# Field Safety Notice

## SBN-CPS-2017-015

### cobas c 501/502 operator injury on USM cover 3

<b>Product Name / Device Identifier</b>	<b>cobas c 501</b> module (GMMI 04745914001) <b>cobas c 502</b> module (GMMI 05964067001)
<b>Affected Instrument Part GMMI / Part No</b>	USM cover 3 (GMMI 05400937001)
<b>SW Version</b>	Not related to the software version
<b>Type of Action</b>	Field Safety Corrective Action (FSCA)

Figure 1: Picture of USM Cover 3 and its thumb screws

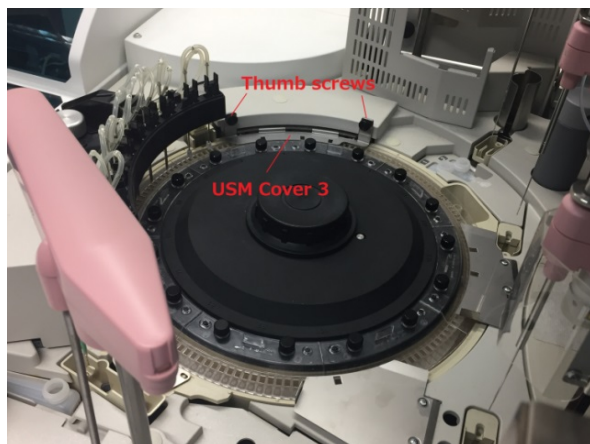
1. The operator was performing monthly maintenance of cleaning the incubation bath and replacing the cuvettes on a **cobas c 502** module.
2. In order to perform Step 1, thumb screws needed to be loosened to remove the USM cover 3, as illustrated in Figure 1.
3. While loosening the left thumb screw, the operator felt a sharp pain in her left thumb and realized that it was bleeding. Her thumb was injured by the 90 degree-edge of the USM Cover 3, which is shown in Figure 2.

Customers are advised not to overtighten the thumb screws when replacing the cover after maintenance. When removing the screws for maintenance, **avoid** touching the edge of USM Cover 3.

Figure 2: Sharp edge of USM Cover 3

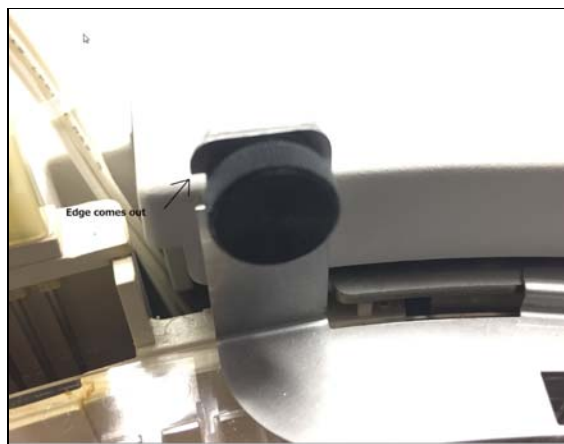
Although the sharp edge of the USM Cover 3 is clearly visible, a medical risk due to an injury cannot be excluded. Since the launch of the product in 2006, only one incident as described above has been reported.

A warning will be added to the respective Operator Manuals, which will be available by December 2017.
